AOV.01 & AOV.02 - UNIT ELEVATION, VIEWED FROM OUTSIDE (2NO IDENTICAL)

SPECIFICATION - AS QUOTED, A PLUS QT51518

THE CLIENT'S REQUIREMENT, AS DRAWN

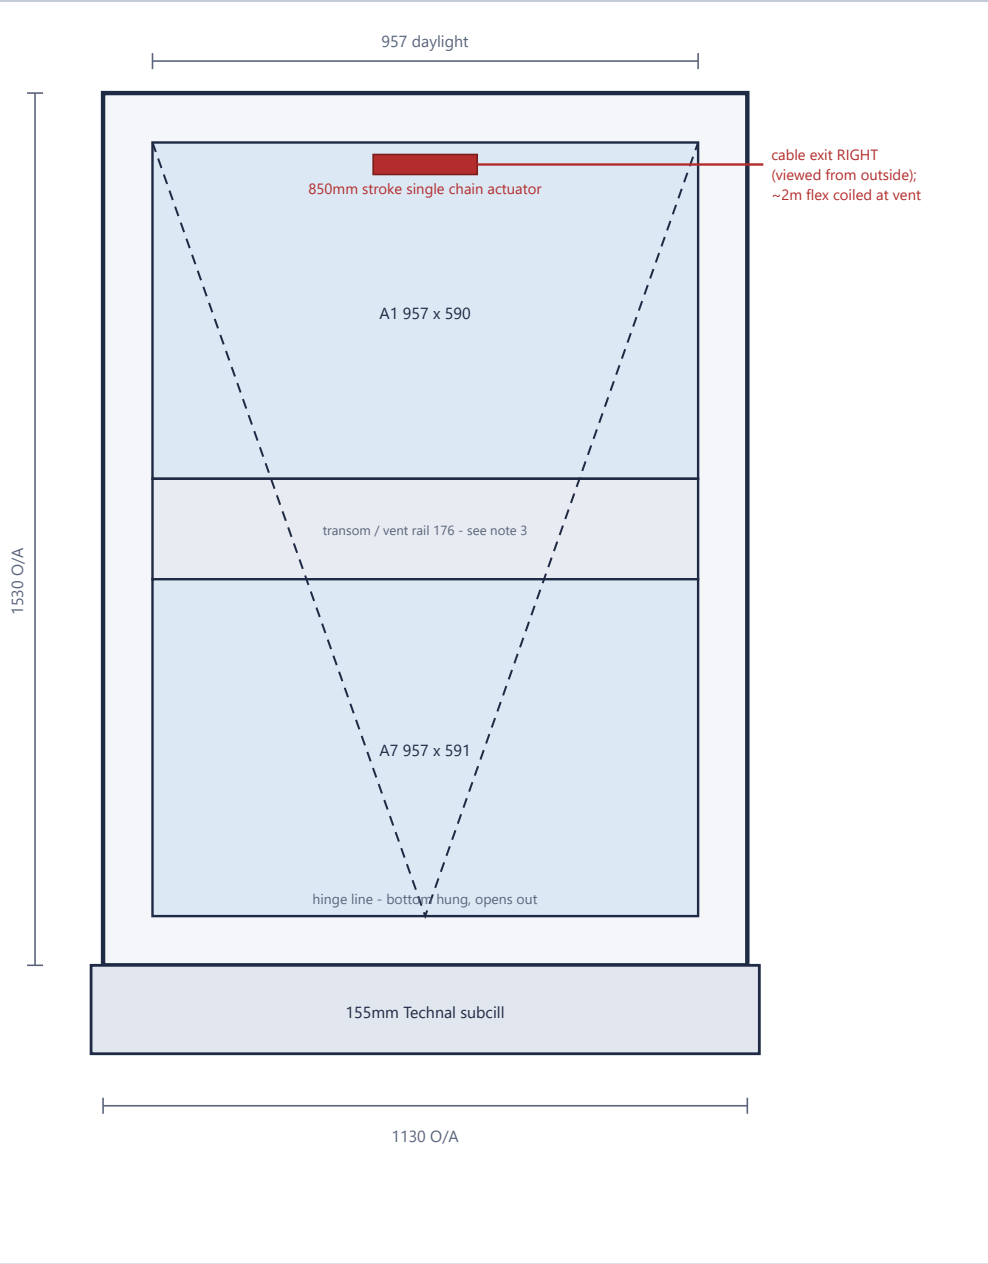
- Sizes and configuration are taken from A Plus QT51518. The tender pack contains **no window schedule and no dimensioned opening** - the 1130 x 1530 originates from Fenster's enquiry of 24/07/2026, not from the architect's drawings.

- Apertures A1 (957 x 590) and A7 (957 x 591) are the glazed apertures stated on the quote, confirming a transom-divided frame.
- The vent leaf is not identified on the quote.** A single 850mm stroke chain actuator is quoted against a frame whose individual apertures are ~590mm high, so the opening leaf cannot be a single aperture. Vent leaf, rail position and actuator position shown indicatively - to be confirmed on A Plus shop drawings before order (RFI-2).

- RFI-1** - A Plus to state the **aerodynamic** free area for 1130 x 1530 at 850mm stroke. QT51518 gives geometric only; their QT51516 states both on every line.
- RFI-2** - A Plus to confirm the vent leaf, rail position and actuator position on shop drawings.
- RFI-3** - Client / fire strategy to confirm whether the 1m² on K1653-11 and K1653-12 is geometric or aerodynamic free area, and to confirm the source of the 1.5m² figure in Fenster's enquiry of 24/07/2026, which does not appear anywhere in the pack.
- RFI-4** - Who is carrying the AOV control system, cabling and fire brigade override?
- RFI-5** - Confirm cill height above FFL at each vent (BS EN 60335-2 trap hazard below 2.5m, Part K anti-fall below 1100mm), and confirm 155mm subcill is acceptable against the 150mm enquired.

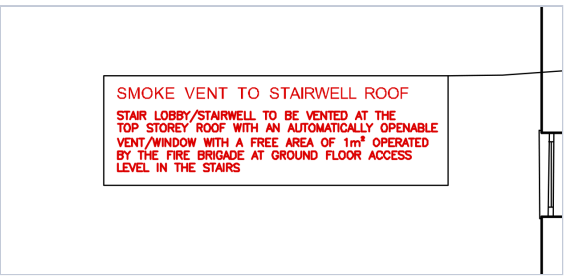
Required (drawings)	1.00 m² free area
Basis	Per stairwell. The note appears once per stairwell, at that stairwell's top storey.
Quoted (A Plus)	1.30 m² geometric
Position	Complies on a geometric reading, with 0.30 m² to spare.
If aerodynamic	A Plus's aerodynamic figures run 60-62% of geometric on the same product (QT51516, Towcester Vale: 0.49/0.81 and 0.54/0.87). On that ratio 1.30 m² geometric is roughly 0.78-0.81 m² aerodynamic - about 20% short of 1.00 m². Indicative only: different sizes, and a 900mm stroke against 850mm here.

The one question that decides this. "Free area of 1m²" is not qualified on the drawing. On a geometric reading the vents as quoted comply comfortably. On an aerodynamic reading they do not, and nor would A Plus's own proposed 1235 x 1583. A Plus must state the aerodynamic figure for the actual Riverside sizes, and the fire strategy must confirm which basis applies.

AOV.01 - Stairwell 1, SECOND FLOOR (top storey of the corner block). Drawing K1653-12, note leader 7.

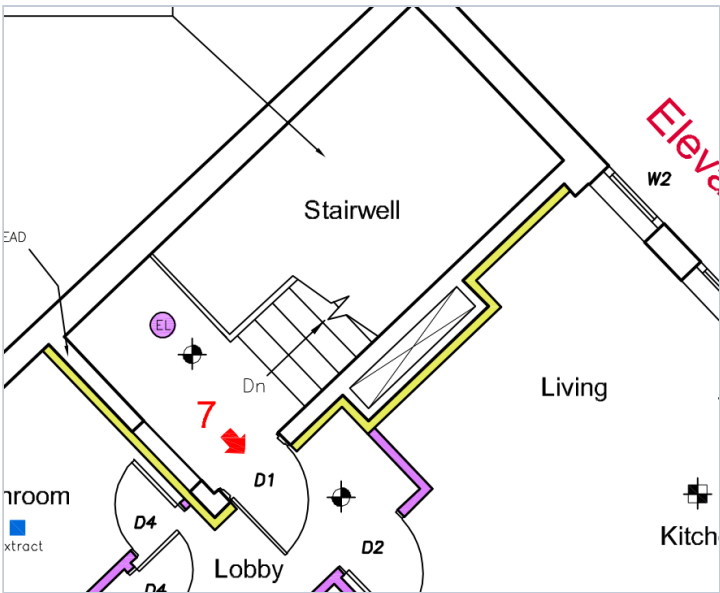
LOCATIONS - ONE VENT PER STAIRWELL, AT THAT STAIRWELL'S TOP STOREY
